Work Order ID 149041

Item Name: Bearpaw Mod - Aerazur Float Compatibility

DART SERVICE INSTRUCTION

TO AMEND INSTALLATION INSTRUCTIONS D350-578 REV. F AND EARLIER
AND INSTRUCTIONS FOR CONTINUED AIRWORTHINESS ICA-D350-578 REV. 1 AND EARLIER

FIGURE 1: INSTALL MOD
(AERAZUR FLOAT AND HARDWARE NOT SHOWN FOR CLARITY)

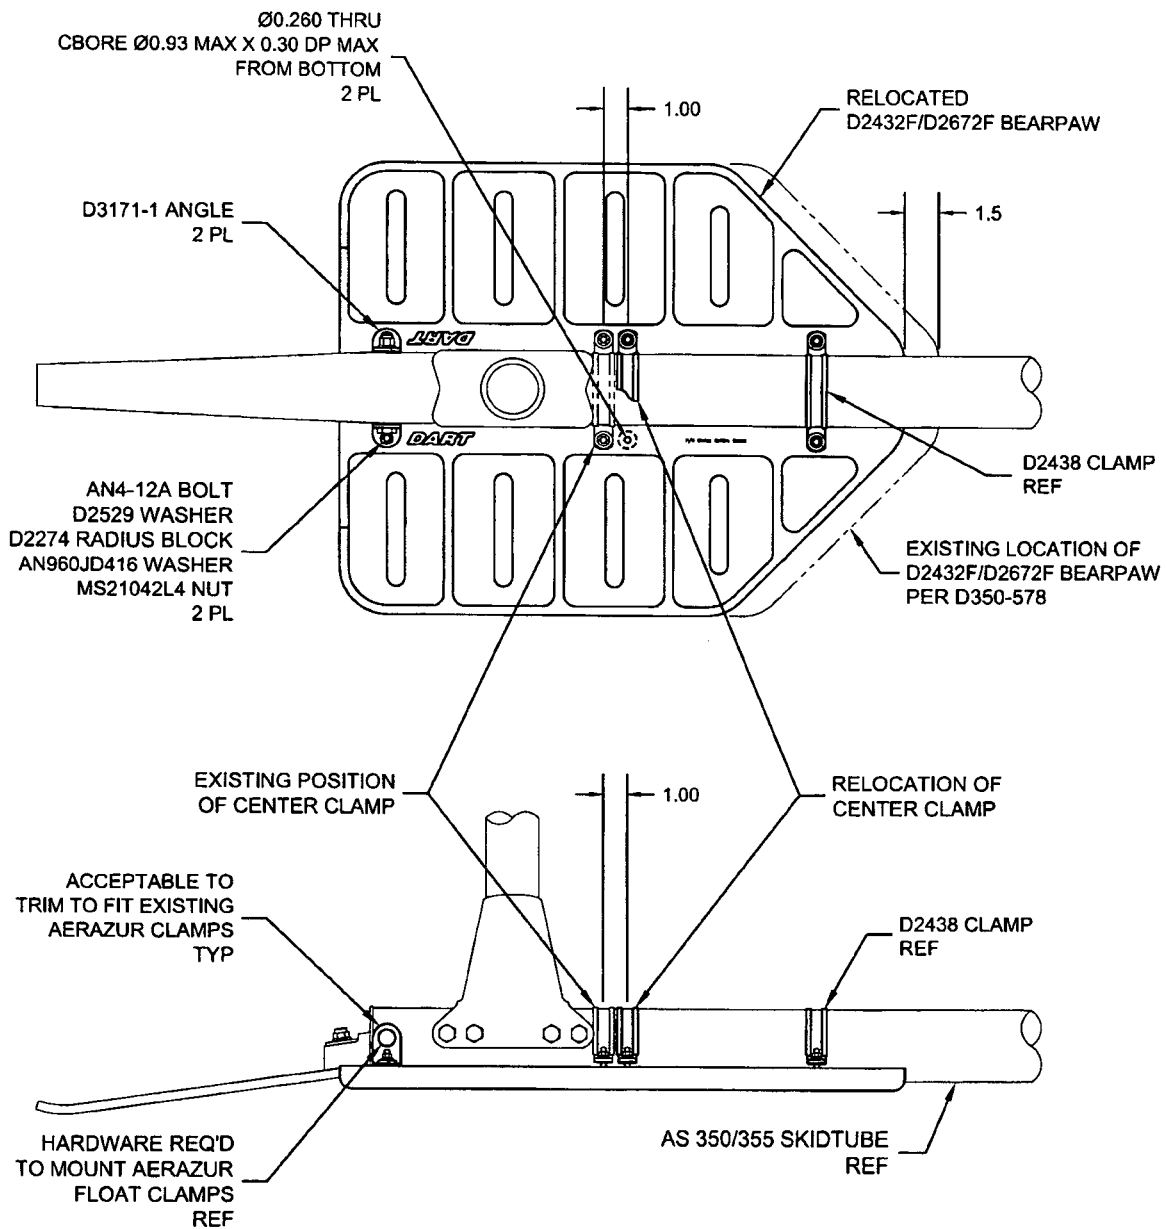
TO ENSURE COMPATIBILITY BETWEEN THE D350-578-011/-021 BEARPAW INSTALLATION AND EXISTING AERAZUR FLOAT SYSTEM, CUSTOMERS ARE ENCOURAGED TO PROCURE DSI-9506-011 KIT LISTED BELOW AND PERFORM THE FOLLOWING DEVIATIONS ON INSTALLATION. REFER TO FIGURE 1.

1. MOVE EACH D2432F/D2672F BEARPAW AFT BY 1.50" MAX;
2. SUBSTITUTE AFTMOST D2438 CLAMP WITH TWO D3171-1 ANGLES TRIMMED TO FIT THE AERAZUR FLOAT CLAMPS ON EACH D2432F/D2672F BEARPAW;
3. ADD EXTRA HOLES/COUNTERBORES (Ø0.260" THRU, C'BORE Ø0.930" x 0.300" DEEP FROM BOTTOM) ON EACH D2432F/D2672F BEARPAW TO MOUNT CENTER D2438 CLAMP TO CLEAR AFT CROSSTUBE SADDLE.
